Following are the mechanical changes that are being made on the model.

1. CHASSIS: -

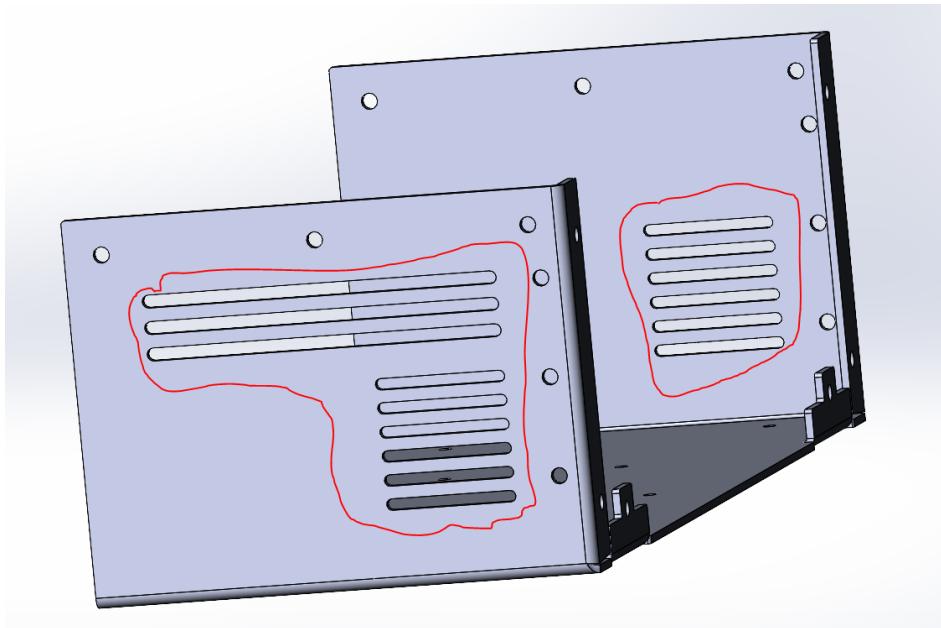
- As per the Feedback I have moved the front mounting holes to the edges.

Q. Are they necessary for improving the rigidity of the enclosure?

- a. Yes, I would recommend to keep the mounting holes as they will help prevent any kind of bowing due to the weight of higher assembly components.
- b. I can't say for certain whether removing the mounting holes would cause bowing, since the exact weight of the higher-level components isn't known. However, adding support mounting holes will help increase stiffness and reduce the likelihood of deformation.

R. REAR :-

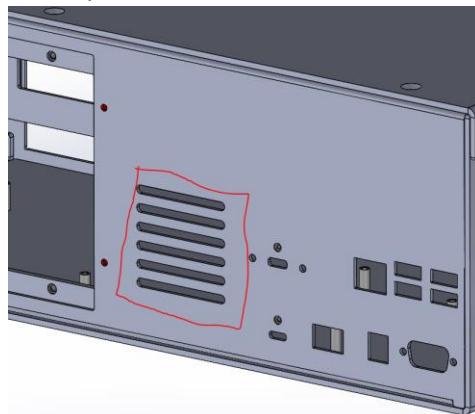
- a. Due to our laser cutting constraint for vent slots, it was highly likely that due to the slots size and spacing, REAR will get warped while cutting the part. In order to avoid any type of warping issues, I have updated the slots on the Rear Panel. Assuming this minor change is acceptable.

-: BETWEEN FRONT AND OFFSET BRACKET: -

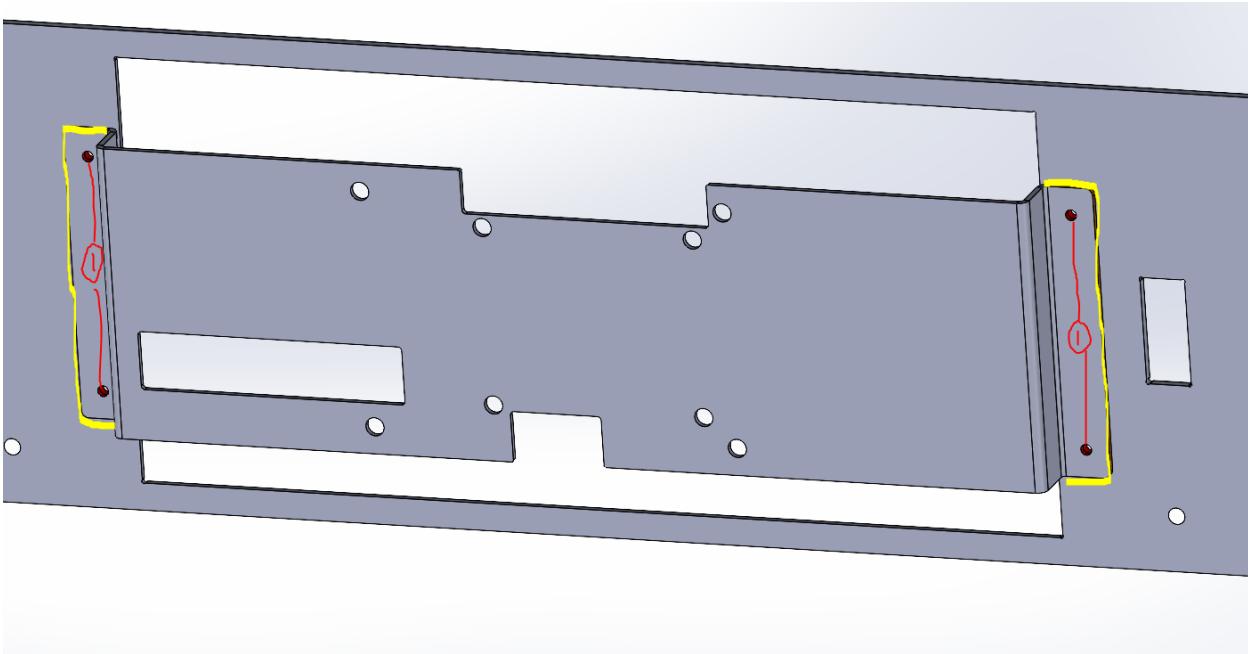
Cutouts marked with red color are for alignment purposes, they will be Plug Welded and Grinded smooth from both sides and will not be visible after welding.

The edges marked with yellow color will be fully seam welded. Assuming this will be ok.

-: BETWEEN REAR AND PANEL: -

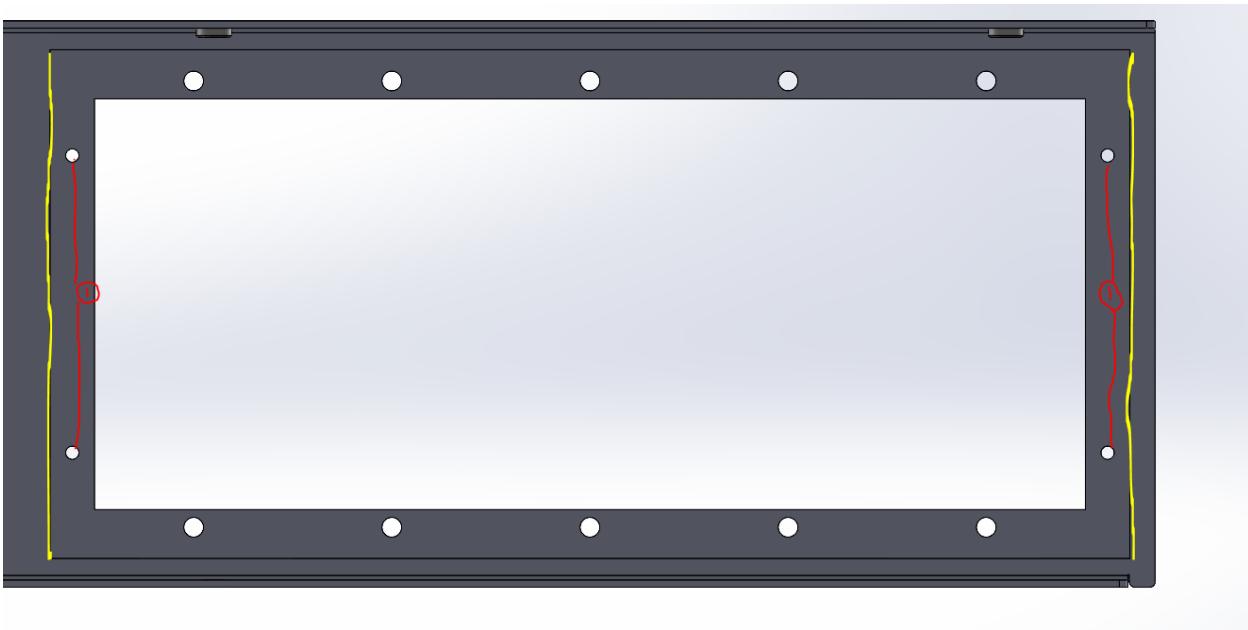
Cutouts marked with red color are for alignment purposes, they will be Plug Welded and Grinded smooth from both sides and will not be visible after welding.

The edges marked with yellow color will be fully seam welded. Assuming this will be ok.

Please note that due to our weld gun constraints, we will not be able to weld the top and bottom edges. (clearance issue with the bent-up flanges of Rear Panel). Assuming that not welding the top and Bottom edges will be acceptable.
